RE: PROPOSED PARK PLAN CONCERNS

**Park Concerns**

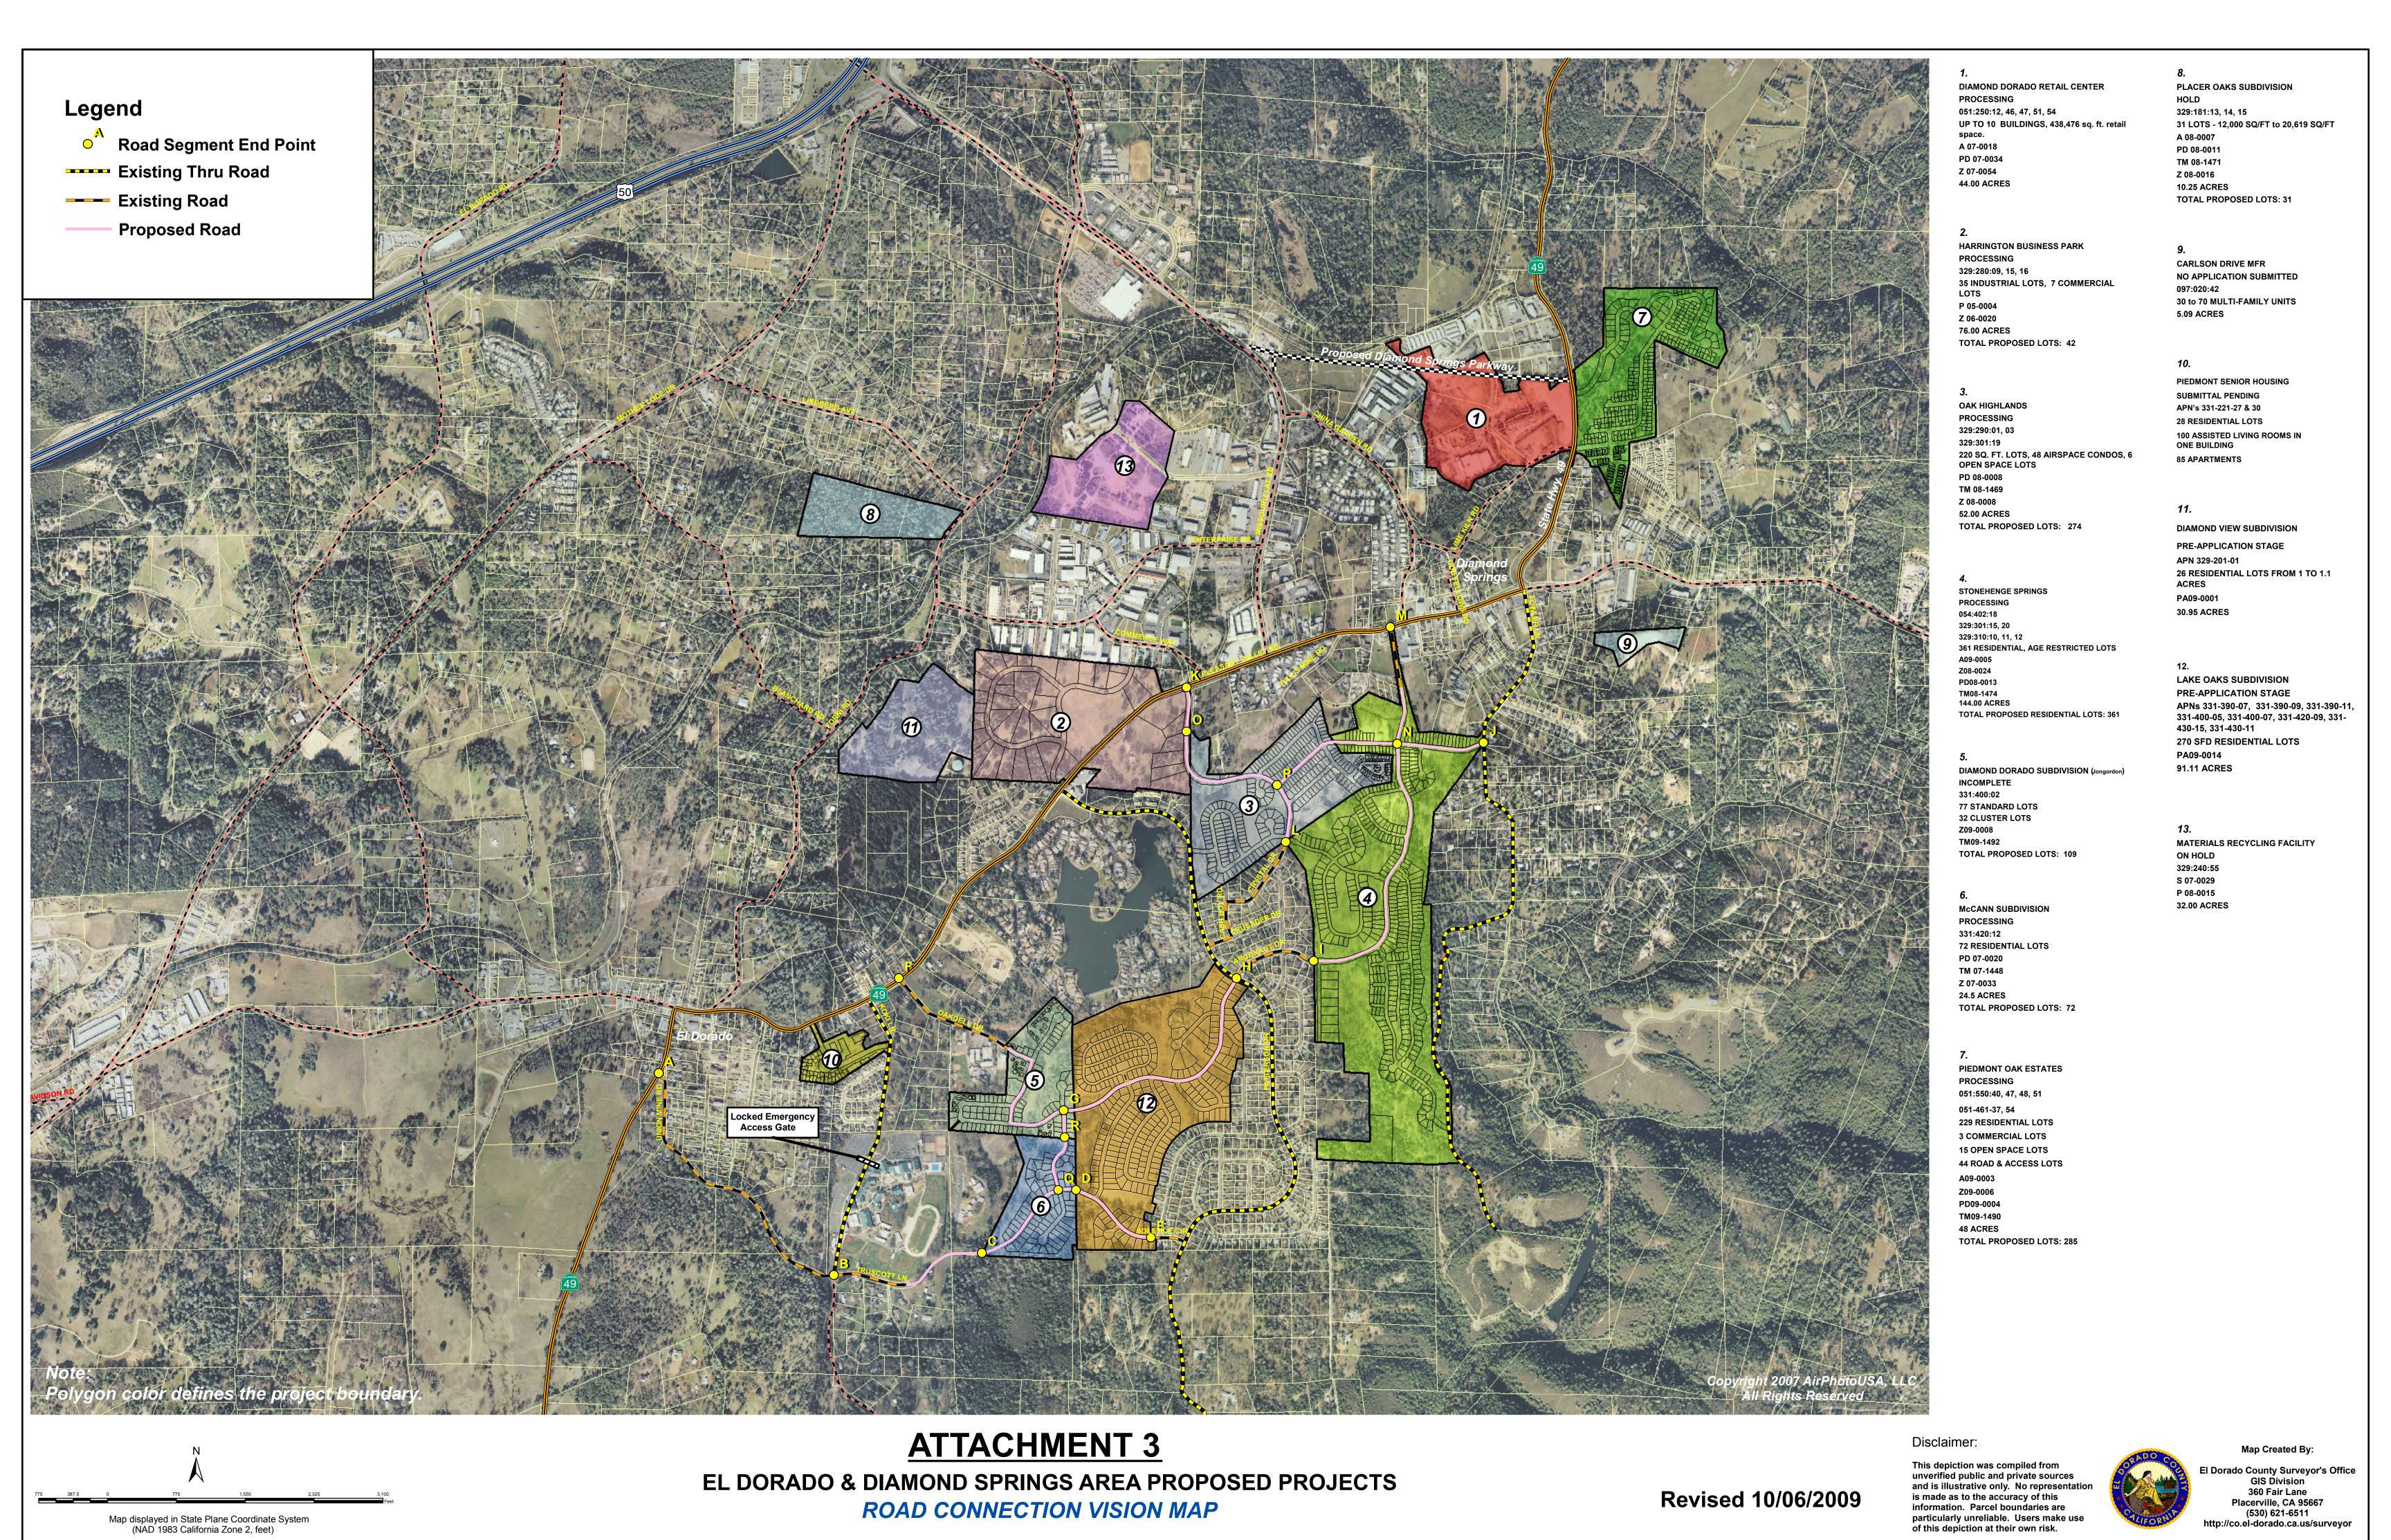
- 1) How do existing Deer Park Area residents and the future residents of vacant lands south and east of the park site access Charles Brown School? Currently they access via Hwy 49.
- 2) The areas south of the park site are extremely susceptible to wildland fires. How would the future residents and Deer Park residents exit when wildland fire occurs? How would fire department access areas south?
- 3) The Diamond Springs and El Dorado Area Mobility and Livable Community Plan illustrated a multipurpose roadway circulation system through existing developed properties and underdeveloped properties lying south of Hwy 49 from Fowler Lane to Union Mine Road and including multipurpose access to

- the High School and Charles Brown School. This project does not conform with the accepted model.
- 4) It is generally accepted that traffic along the Highway 49 corridor and particularly through Diamond Springs should be minimized whenever and however possible. The Diamond Springs and El Dorado Mobility and Livable Community Plan illustrates how to move people, bikes, and vehicles south of Hwy 49 to the two school sites and the future park site. Residents living locally should be afforded access through their neighborhoods to the schools and the future park site without adding to congestion on Hwy 49 and particularly downtown Diamond Springs.

- 5) Park concepts A and C illustrate vehicle lanes as well as parking bays. The vehicle lanes need to extend east to provide future ingress and egress from the park site. The vehicle lane from the lift station easterly needs to be identified and included in the project description. The construction of that improvement can be deferred until properties south and easterly develop; but it is imperative that the access be identified and included as part of the park project. The development of vacant lands east and south of the park lite will necessitate the relocation and

upgrade of the existing lift station. Those future developments would construct the roadway, but the park plan needs to include the proposed future ingress and egress.
